## POLICY REPORT DEVELOPMENT AND BUILDING

TO: Vancouver City Council  
FROM: Director of Planning  
SUBJECT: CD-1 Rezoning - 6511 Granville Street

Figure 2: Building Layout and Setbacks

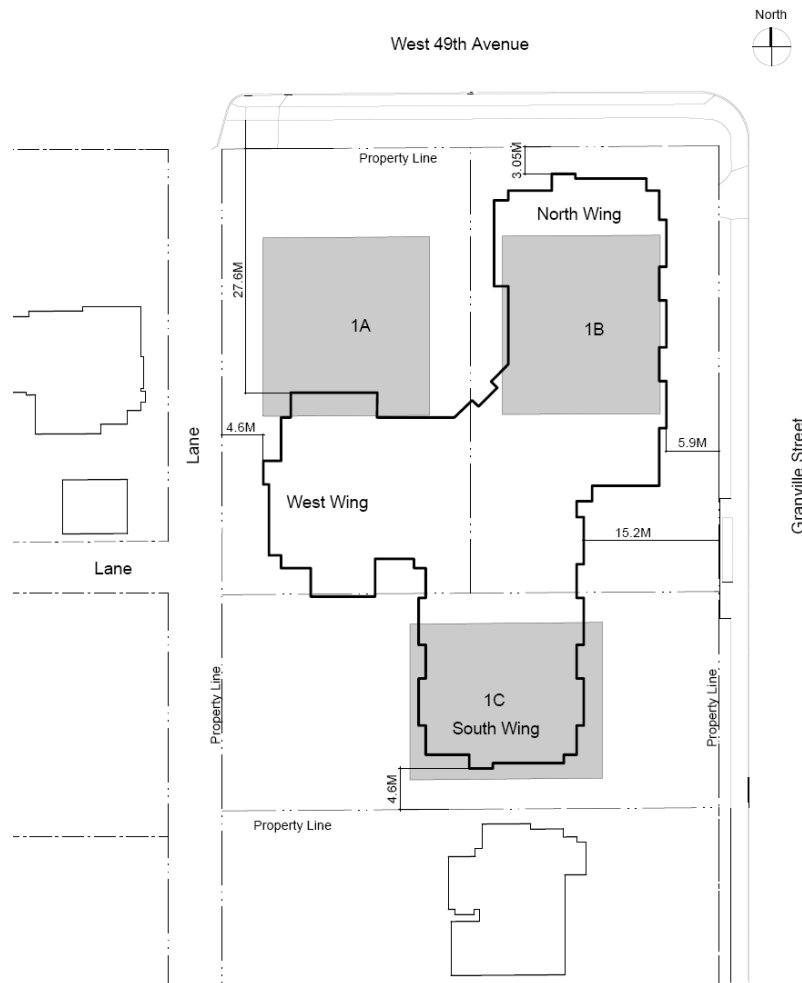
The proposed building orientation and layout results in three building wings: the south, north and west wing (see Figure 2). The proposed location of building wings on the site respects the front yard relationships to adjacent properties and addresses the impact of the proposal for adjacent neighbouring properties. Figure 2 shows three shaded areas that illustrate typical building footprints that would result if the site were developed with three single-family houses under RS-6. The south wing is located such that it is consistent with front and rear yards that would be required if that parcel were developed under the existing zoning. As well, the setback from the south property line is greater than the side yard setback that would be required under existing zoning. The west wing is set back further from 49th Avenue than adjacent houses to the west. The north wing does encroach further north toward 49th Avenue, however this northeast corner of the site is the appropriate location to receive building massing because there is the least impact on surrounding properties with regard to overlook and privacy. The side yard condition for the north wing, adjacent to Granville Street is consistent with the RS-6 side yard requirement.

Staff conclude that the appropriate relationship has been achieved with the dwelling to the south with the prescribed setbacks and reductions in massing [see Appendix B, conditions (b)(i), (b)(ii), and (b)(iii)]. Separation from neighbours to the west is assisted by the width of the lane, and by the orientation of new windows toward the north and south. Staff find the proposed setbacks acceptable as they are used to provide common outdoor space for residents and the separation distances between the proposed building and adjacent properties are adequate. Staff have included design development conditions to ensure that the proposed setbacks are maintained if the rezoning is approved (see Appendix B).

- (ii) Design development to provide minimum setbacks as follows:
- from north property line (West 49th Avenue) - 3.05 m (10 ft.);
  - from south property line - 4.6 m (15 ft.);
  - from west property line - 3.05 m (10 ft.); and
  - from east property line - 5.85 m (19.2 ft.).

- (iii) For the south wing of the building the setback from the east property line should be comparable to the front yard dimension of neighbouring properties for approximately half the length of the site.

- (iv) For the west wing of the building the setback from the north property line should be greater than the front yard setback of neighbouring properties to the west for approximately half the length of the site.
- (v) Design development to the base of the building to avoid a horizontal expanse of relatively undifferentiated stucco, and to achieve a stronger residential expression at grade;

**A-301**

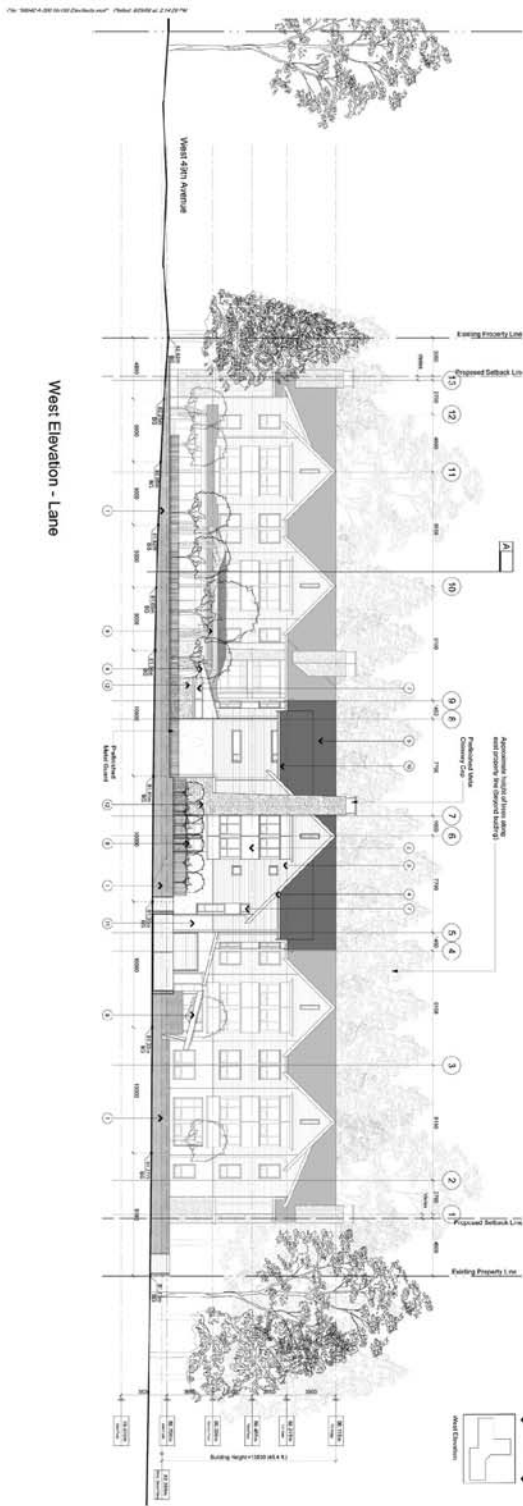
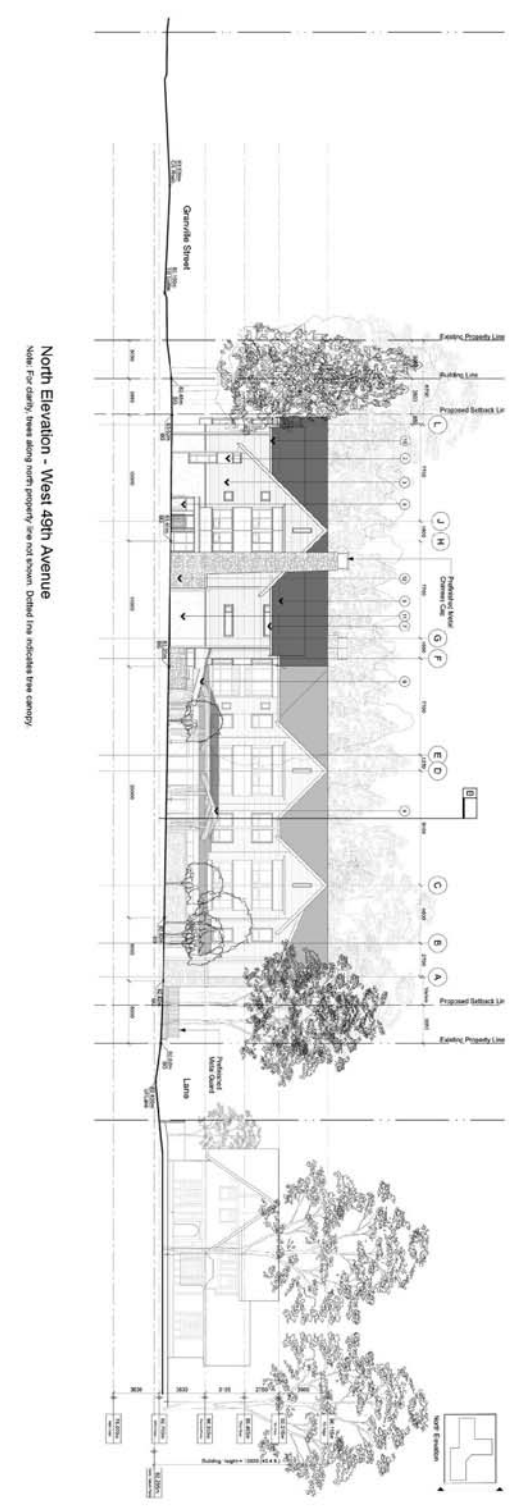
- (i) Design development to reduce the scale and massing of those portions of the building facing single-family residential properties;

Note to Applicant: This can be accomplished by lowering portions of the building at the edges by approximately 1.5 m or about 13 m above grade, by varying some of the ridge lines of the project, by following grade more closely, or some combination thereof. Similar adjustments should also be considered on the north façade to reflect the residential streetscape to the west. The characteristic pitch of the gable ends should be maintained.

Note to Applicant: This can be addressed by using horizontal siding or masonry in place of stucco, by adding window trim that is more consistent with the residential character of the upper floors, and by adding patio doors for residents to directly access the outdoor spaces. (See also condition (b)(xvii) regarding further development of the outdoor area)

- (vi) Design development to the northeast portion of the building to better respond to this active and prominent intersection;

Note to Applicant: Consider a stronger and more distinctive expression for these bays of the building.
